STAFF REPORT
COMMUNITY DEVELOPMENT DEPARTMENT

DATE: 10/21/2025
TO: City Council
FROM: Sonya Allen, Associate Planner
208-884-5533
sallen@meridiancity.org
SUBJECT: FP-2025-0009
District Ten Mile Subdivision No. 1

Final plat consisting of 17 buildable lots on 34.04 acres of land in the C-G zoning district for the first phase of District Ten Mile Subdivision.

Page 8

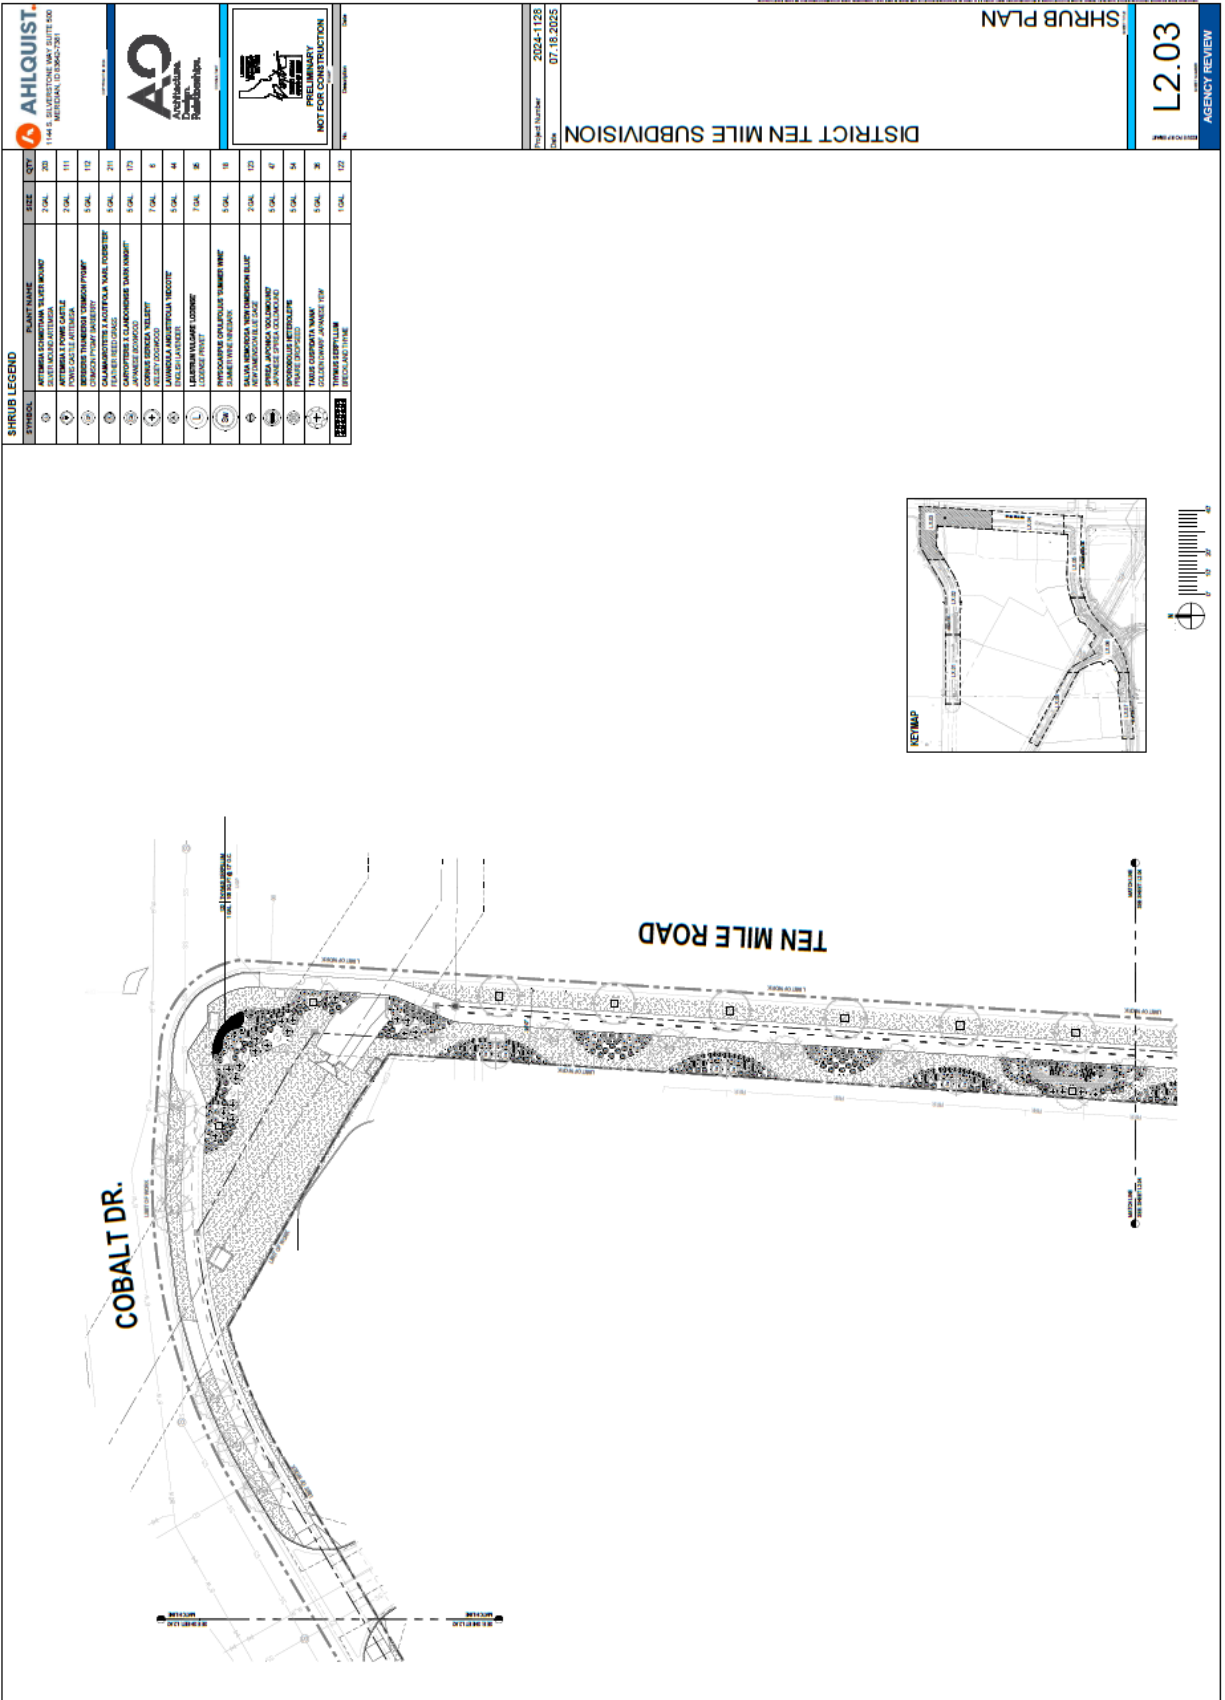
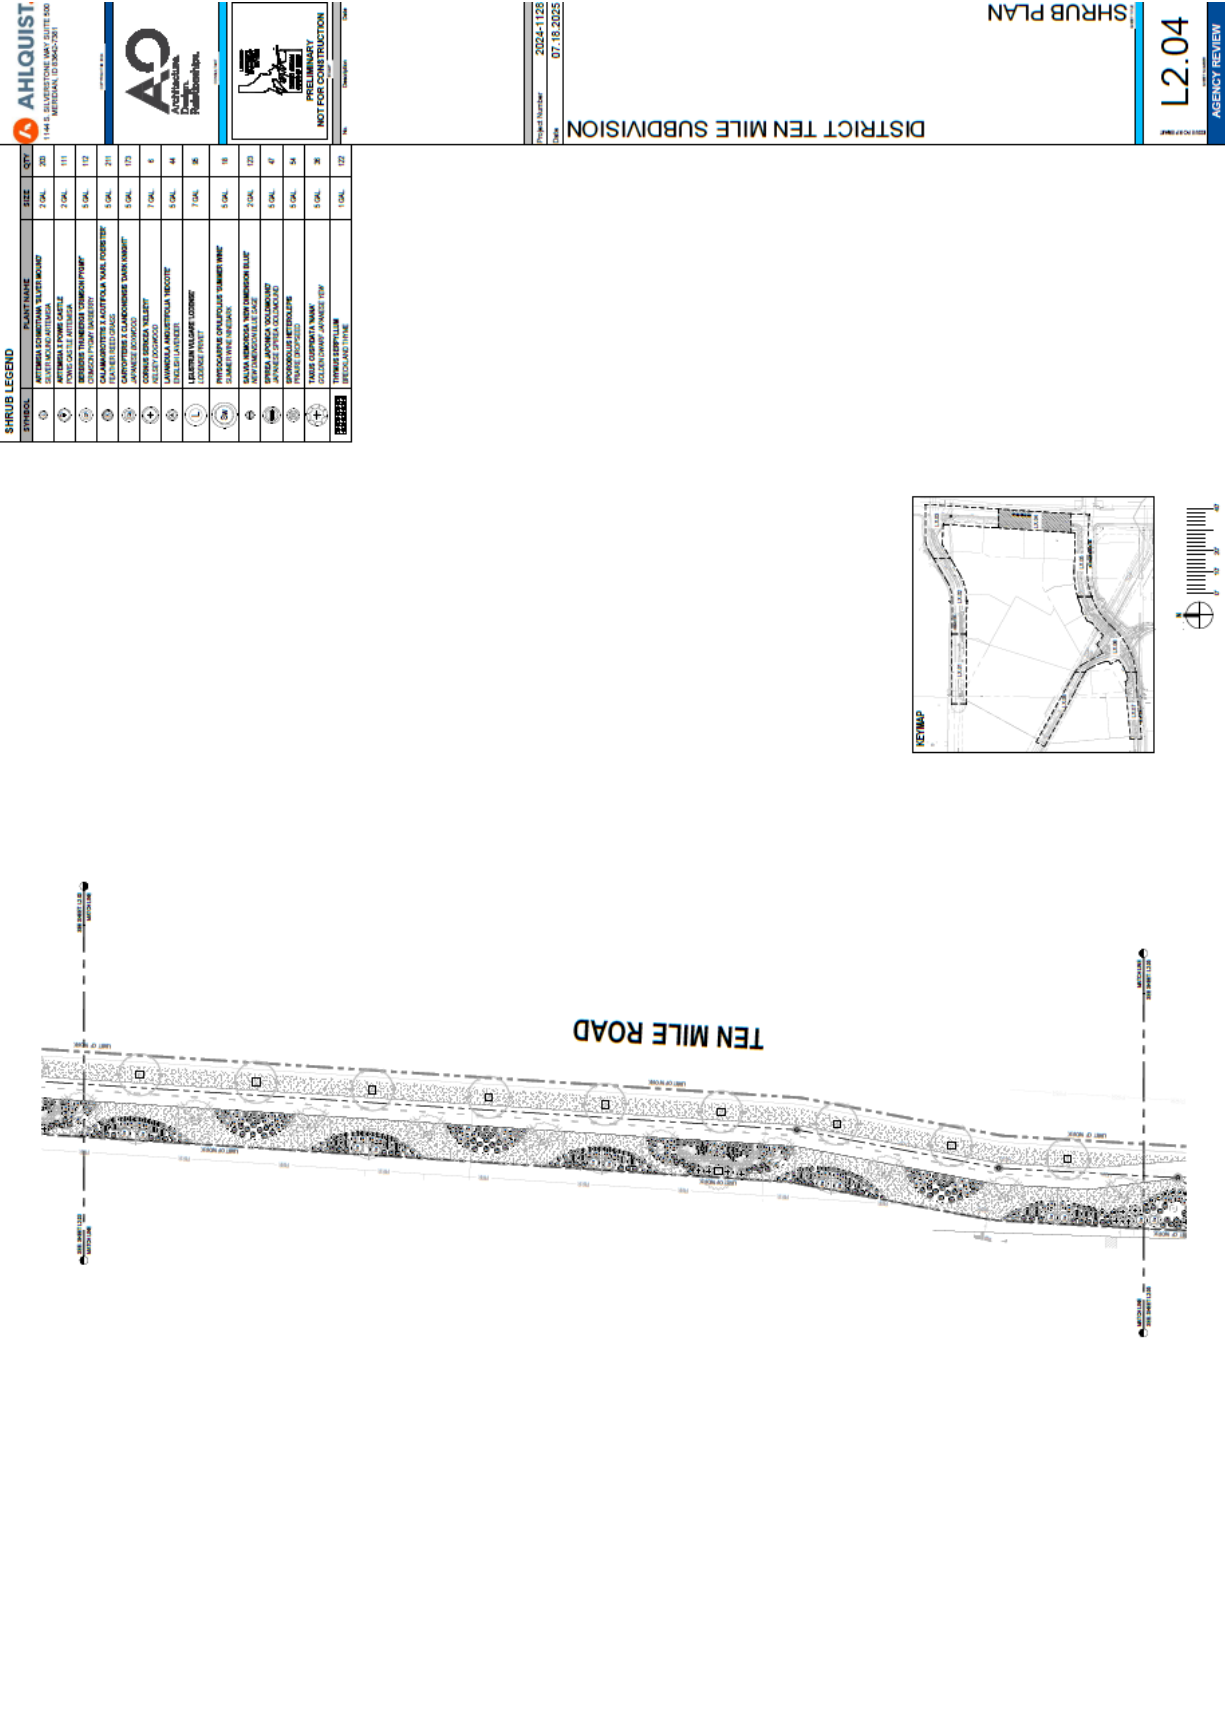
- a. Depict 10-foot-wide detached sidewalks/pathways in the street buffers along N. Ten Mile Rd. and W. Grand Mogul in the areas where 6-foot-wide walkways are currently depicted near the intersections of Grand Mogul/Ten Mile and Cobalt/Ten Mile unless a physical barrier exists that prevents compliance.

- b. Depict landscaping within the street buffer along W. Grand Mogul Dr. in accord with the standards listed in UDC 11-3B-7C.3 (i.e. depict a variety of shrubs and vegetative groundcover along with the 37 trees that elicit design principles including rhythm, repetition, balance and focal elements). Also revise the Project Calculations table on Sheet L1.00 to reflect a total of 37 street trees are proposed in the buffer.

- c. Depict landscaping along the multi-use pathway adjacent to the Purdam Drain in accord with the standards listed in UDC 11-3B- 12C (i.e. 5-foot-wide landscape strips are required along each side of the pathway planted with a mix of trees, shrubs, lawn, and/or other vegetative groundcover – a minimum of one tree per 100 linear feet of pathway is required – include calculations in the Project Calculations table that demonstrate compliance).

- d. Widen the 5' wide parkways depicted west of first driveway off Grand Mogul to 8' consistent with Street Sections B & C in the TMISAP.
- 6. A Certificate of Zoning Compliance application shall be submitted and approved for all development on the site prior to submitting any associated building permit applications.
